STAFF REPORT

TO : ACPC
FROM : Planning Bureau
RE : RE-ZONING ON FRONT STREET (Z Case #20-1)
DATE : February 22, 2021

Figure 2. Land use map showing current land uses in the parcels for rezoning to B-5 and adjacent parcels.

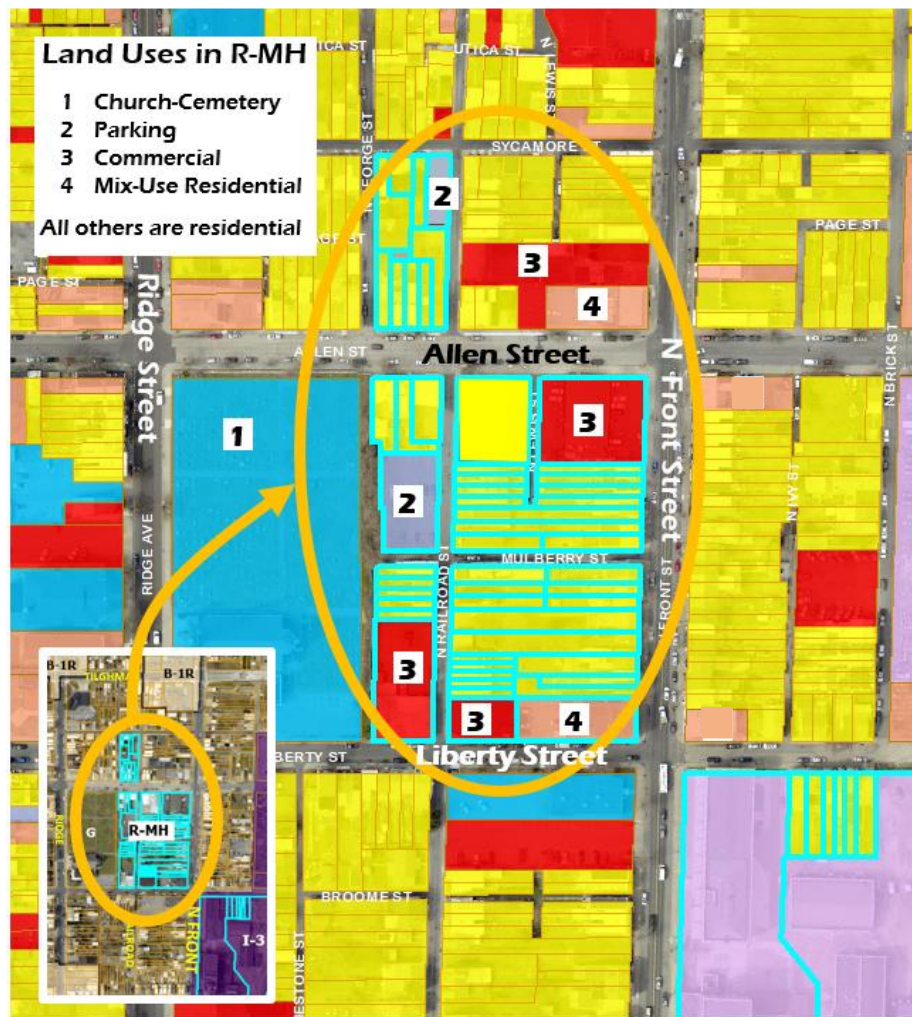
5) On the other hand, for the parcels west of Front Street which are currently zoned R-MH – and proposed to be re-zoned to B5 (refer to Figure 2) – Staff did not favor such re-zoning based on the finding that the current and emerging land uses in these parcels and in those abutting properties in the vicinity are predominantly residential:

- a) Reviewed by parcel, of the 51 total parcels in those 5 city blocks, only six (6) parcels or 12% of that total number are deemed compatible to B5 uses. These parcels are labeled 2, 3 and 4 in Fig-2. In other words, 88% of the parcels are used for residential purposes, mostly of the single-family type.
- b) Reviewed by acreage, those same parcels labeled 2, 3 and 4 (in

- c) Based on the foregoing findings, Staff is of the view that it is deemed not proper to down-zone a cluster of parcels from a predominantly residential use to a less-protected land use (which, in this case is a commercial district just a zoning class above light industrial).

- d) That said – and with due regard to basic land use principles and good zoning practice - Staff deems it improper to designate – in a predominantly residential area – a commercial district that promotes intensive land uses whose operational characteristics will have inimical impacts to the established residential uses in the area.
